CHANGE 1 TO HF-KWM-380 SERVICE BULLETIN NO 17

HF-380 TRANSCEIVER (622-3580-001) KWM-380 TRANSCEIVER (622-5093-001) RECEIVER-EXCITER CIRCUIT CARD A3 (638-6908-002)

SERVICE BULLETIN NO 17

MAKE TRANSCEIVER RECEIVER-EXCITER BOARD COMPATIBLE WITH CU-380 COUPLER

P/O Receiver-Exciter Circuit Card A3, Schematic Diagram Figure 2 (Sheet 1 of 3)

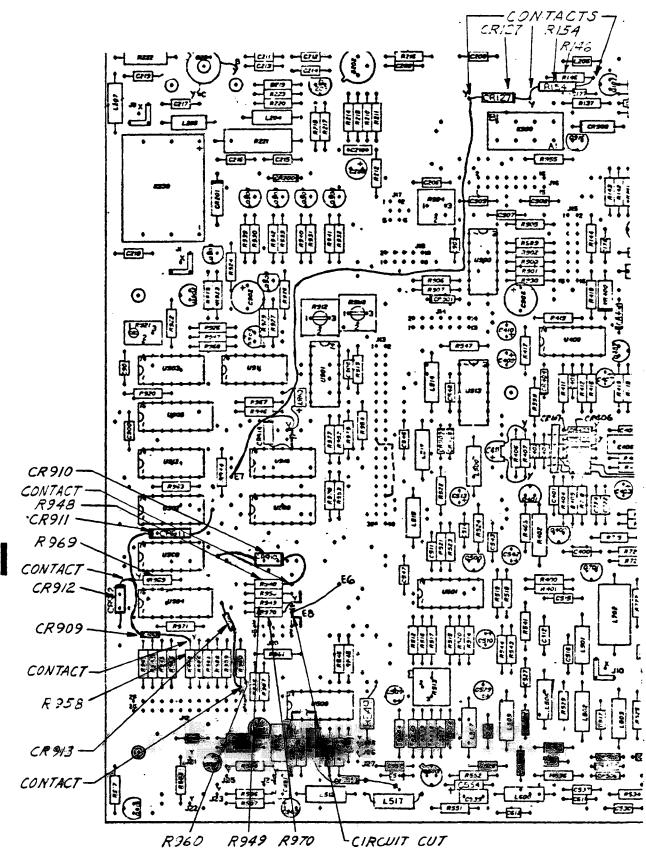
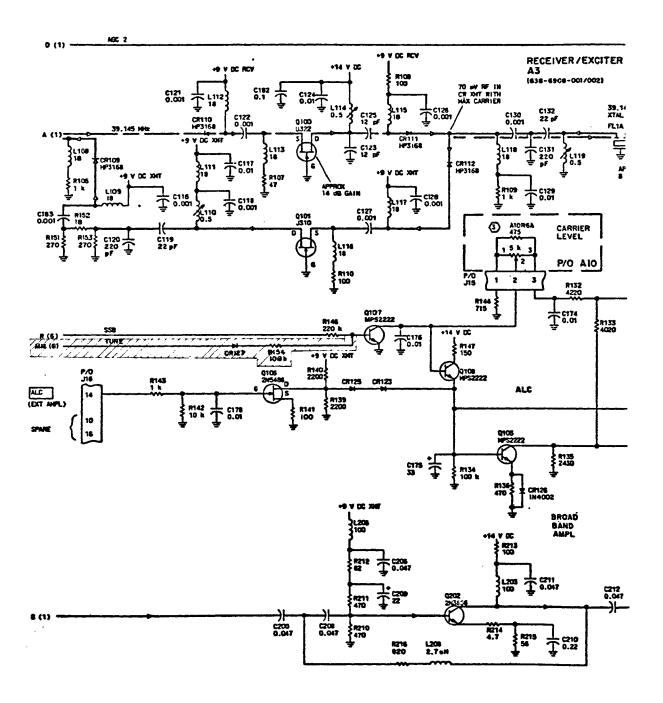
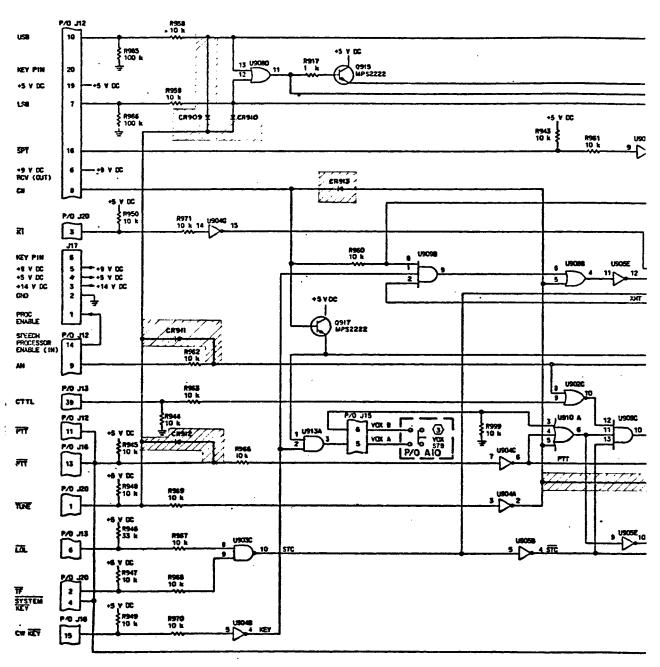
Taking care to not damage adjacent components, this modification can be made without removing A3 from the chassis. Refer to figure 1 for location of components. Refer to figure 2 for a schematic diagram which includes the changes made by this service bulletin.

The change consists of adding six contacts, six diodes, one resistor, two jumper wires, and making one circuit trace cut.
